IN THE DRAWINGS:

R e m a r k s

ANNOTATED SHEET

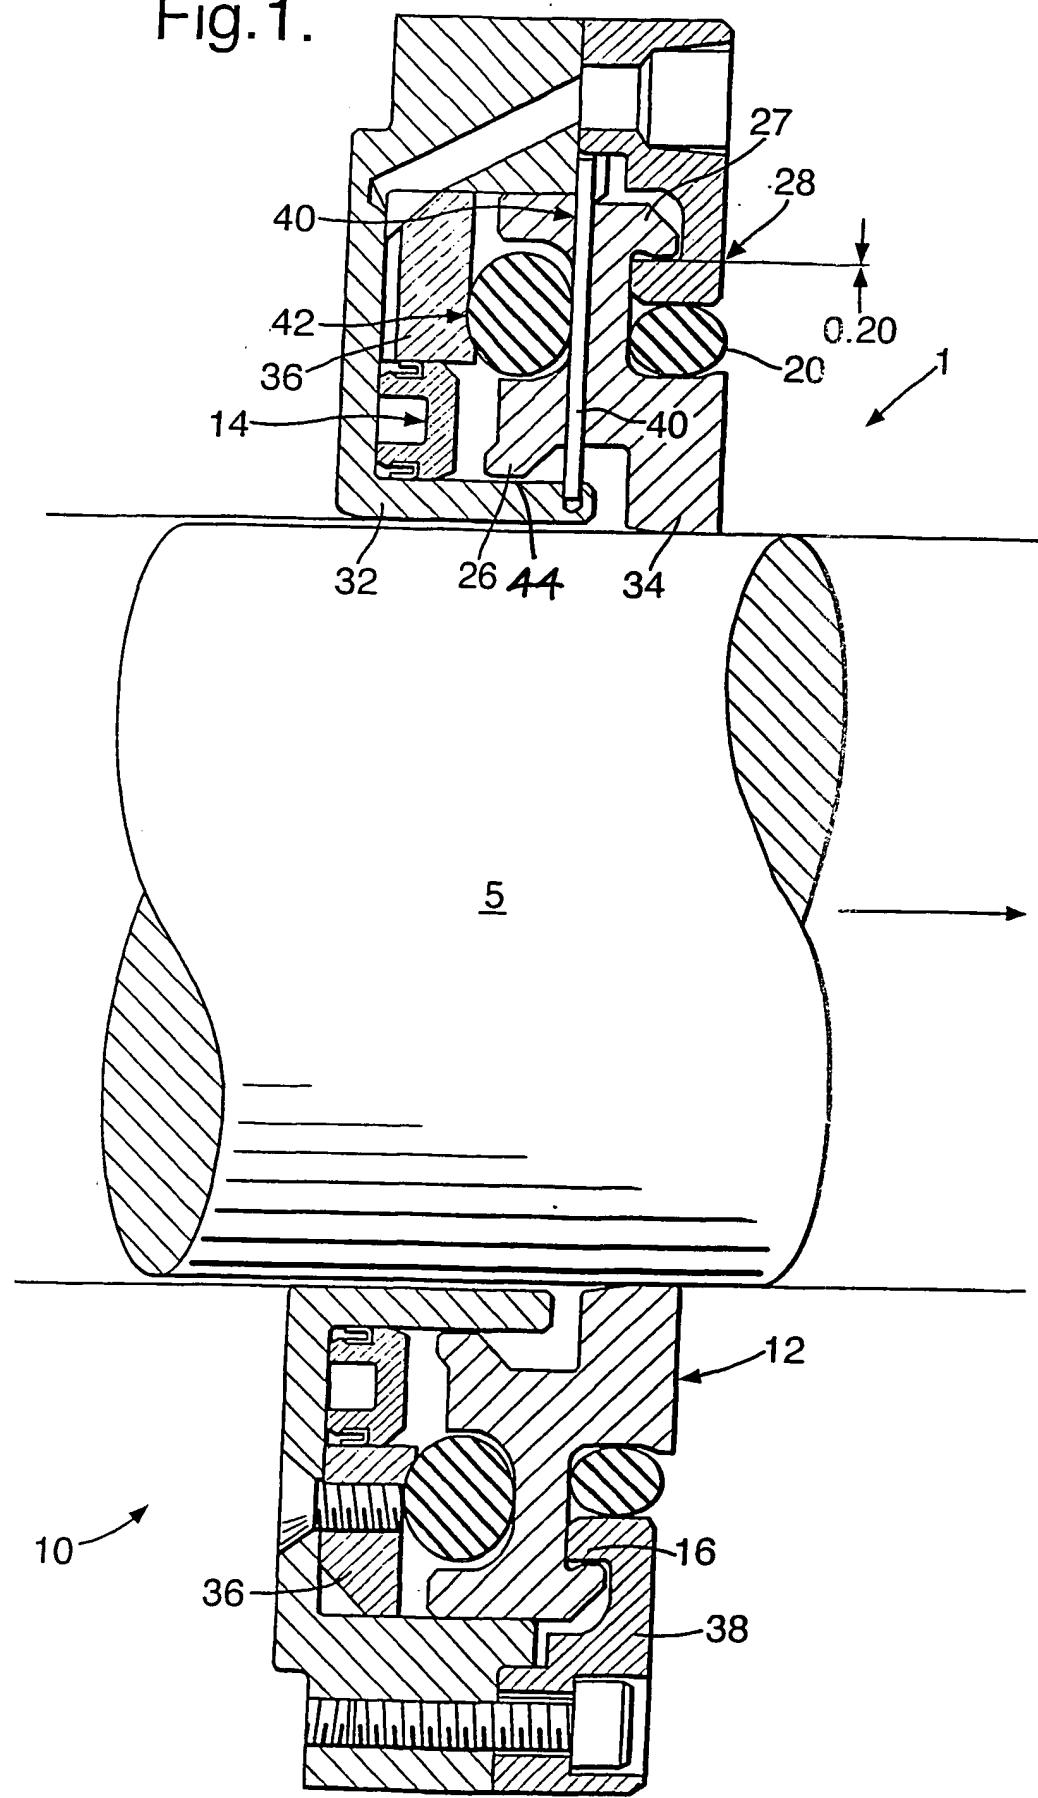
Two new sheets of drawings are submitted as "Drawing Replacement Sheets" of Figures 1 and 3 along with the corrected "Annotated Sheet Showing Drawing Changes." The Annotated Sheets reflect the addition of reference numbers 44 and 58 to Figures 1 and 3, respectively, and the elimination from Figure 3 of reference numerals 56 and 57.

Turning first to the various objections presented by the Examiner with respect to the drawings beginning at page 2, paragraph 1, the "contact point 58" has been designated by the latter reference numeral in Figure 3. Accordingly, this objection has been rendered moot.

The objection with respect to reference numerals 56 and 57 has also been rendered moot by deleting each from Figure 3 of the drawings.

The final objection concerns the arrow from reference numeral 44 (Office Action, page 3, paragraph 3). The lead line from reference numeral 44 now correctly identifies the "gap" intended.
